SUBJECT: Forwards comments on 841126 draft NPDES Permit PA0047325.
 Flow & ph monitoring requested to be required only on days
 that discharges made to Sedimentation Pond S-2. Requests
 deletion of max daily & instantaneous max iron limits.

SUSQUEHANNA STEAM ELECTRIC STATION
NPDES DRAFT PERMIT COMMENTS
PERMIT NO. PA0047325
CCN 741326 FILE 012
PLE- 6614

COMMENTS ON EFFLUENT LIMITATIONS AND MONITORING REQUIREMENTS

HISTORICAL WEEKLY COOLING TOWER BLOWDOWN VS. SUSQUEHANNA RIVER

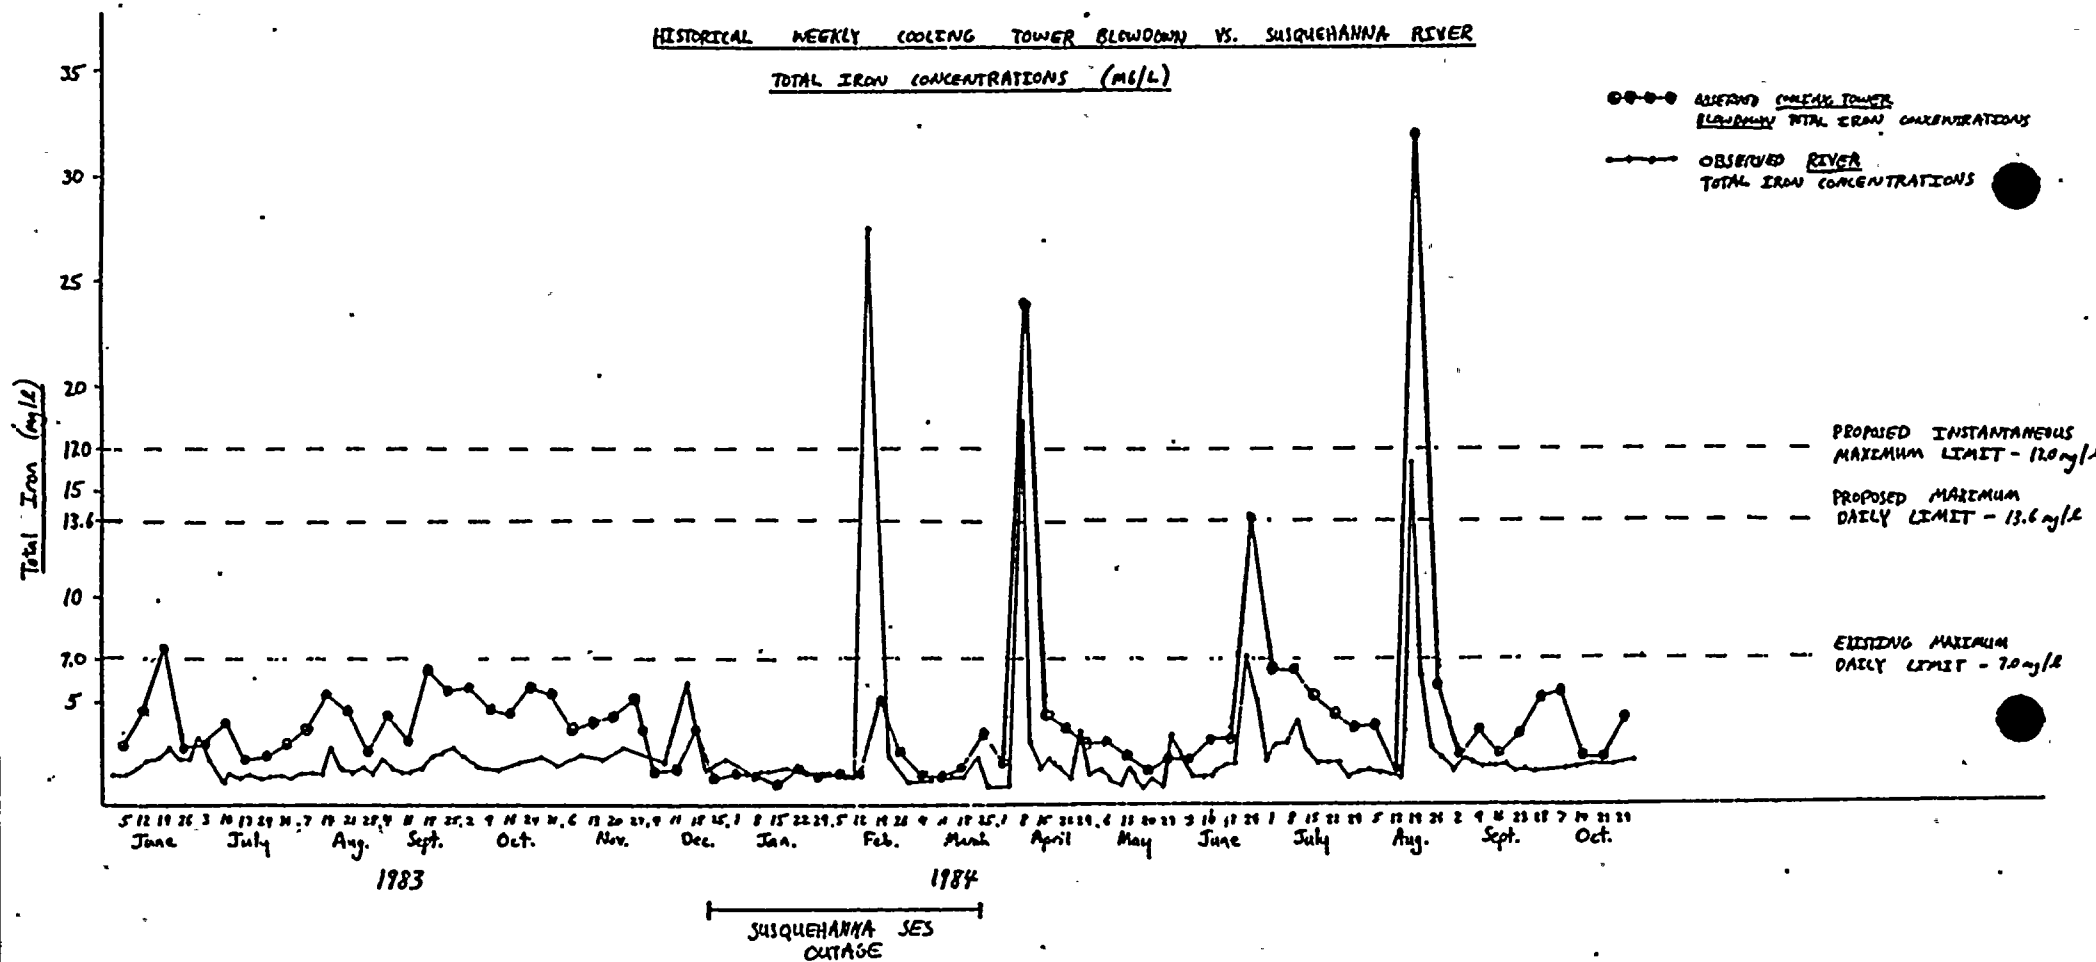
As stated above, maximum iron concentrations in the river often exceed the average concentrations observed by greater than a factor of six, and the Susquehanna SES's cooling tower blowdown discharge varies accordingly. However, the Pa. DER proposes to establish maximum concentration limits by using factors of only 2.0-2.5 times greater than average limiting concentrations. Establishing effluent limits in such a manner is overly-restrictive since it does not take into account the true variability in the quality of the discharge, which is due solely to intake water quality. Establishing such effluent limits does nothing to protect water quality; it merely subjects PP&L to NPDES permit violations which are beyond PP&L's control.

PP&L recommends the deletion of the maximum daily and instantaneous maximum limits or, at a minimum, the establishment of maximum limits which reflect the true variability in the effluent quality. If the Pa. DER insists on establishing maximum limits PP&L recommends use of a variability ratio of approximately six (based on maximum observed/average observed iron concentrations in both the raw water supply and cooling tower blowdown presented in Attachment 1). Using

this approach, the appropriate maximum daily limit would be 6.8 mg/l (monthly average limit) x 6 or 40.8 mg/l.
